**Drinking Water
Engineering and Science
Discussions**

Interactive comment on "Rapid evaluation of water supply project feasibility in Kolkata, India" *by* K. Dutta Roy et al.

Fig. 1. Flow Diagram of the Cost benefit Analysis

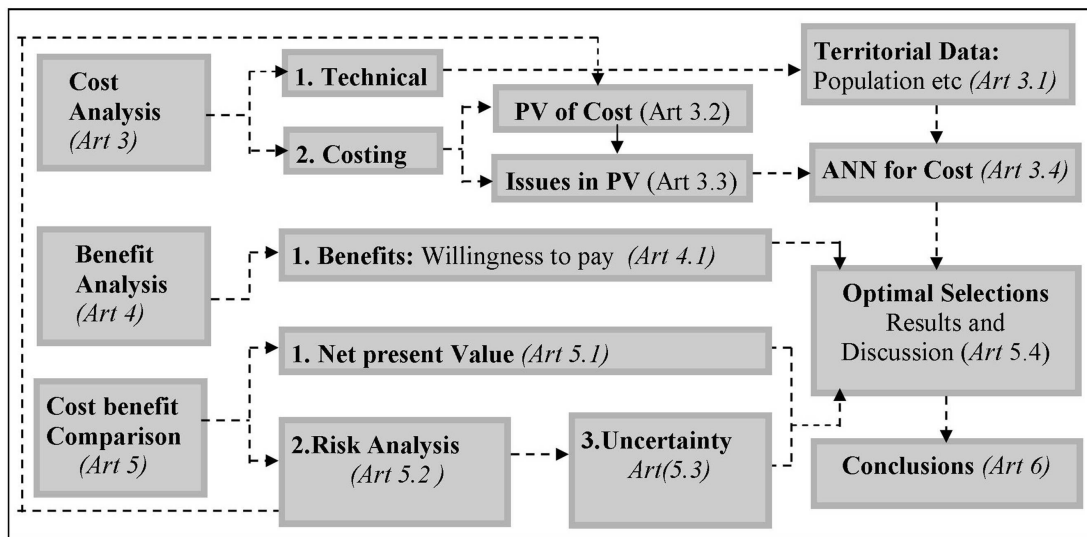
Observation 1: Emphasize those aspects of the paper that are unusual

Response: A methodology for rapid cost-benefit assessment suitable for Kolkata has been proposed in the paper. A flow diagram prepared at the advice of the Reviewer 1 (Fig. 1, P: C5 of the earlier author comment) has been again presented in Fig. 1. It would emphasize the point that the methodology rather than the individual tools are important for the paper. In addition, the results of the study have been presented in Fig. 5 (P: 104 of discussion paper) and in Table A1 (P: 99 of the discussion paper) which
